30-233C BRAKE ASSEMBLY – 075-01500 TORQUE PLATE – INSPECT/REPLACE

This document provides the necessary instructions to replace the torque plate, P/N 075-01500 with P/N 075-01502.

Figure 1 Torque plate comparison

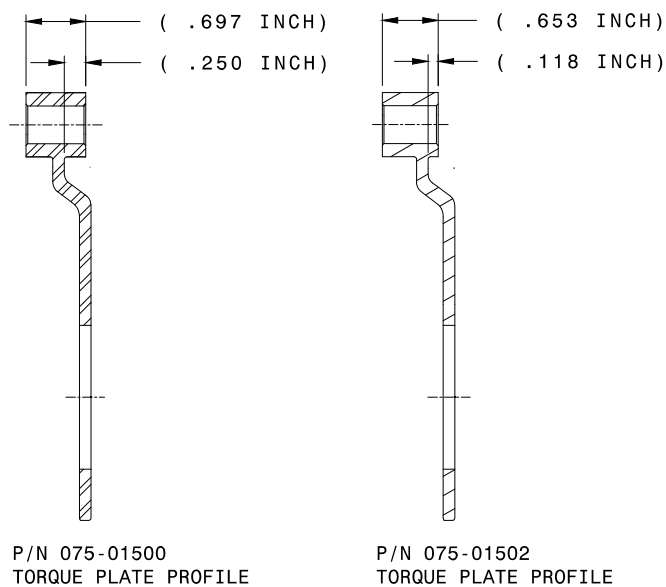
To improve functional interface with aircraft axle mount. Parker Hannifin has received reports indicating that the offset provided by the current axle flange location with the torque plate, P/N 075-01500, may cause lining to disc interference during taxi operations.

- (1) Torque plate comparison. Refer to Figure 1.

Figure 2 Torque plate interface

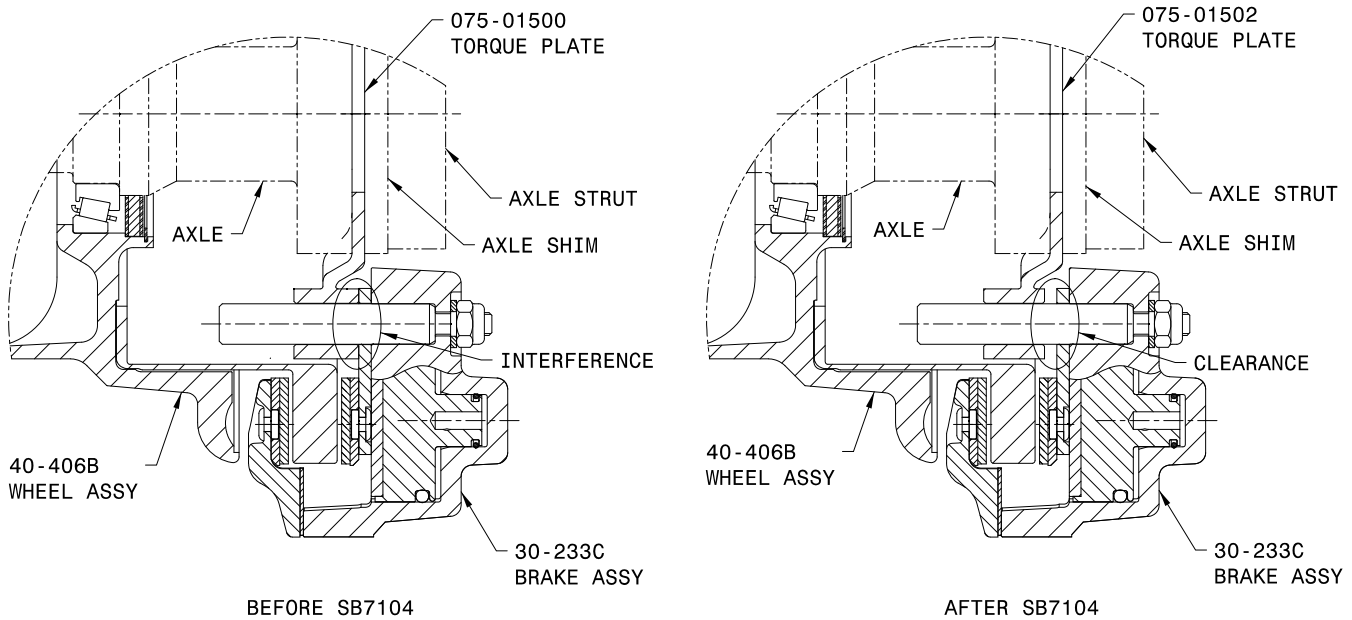
(2) Torque plate interface. Refer to Figure 2.
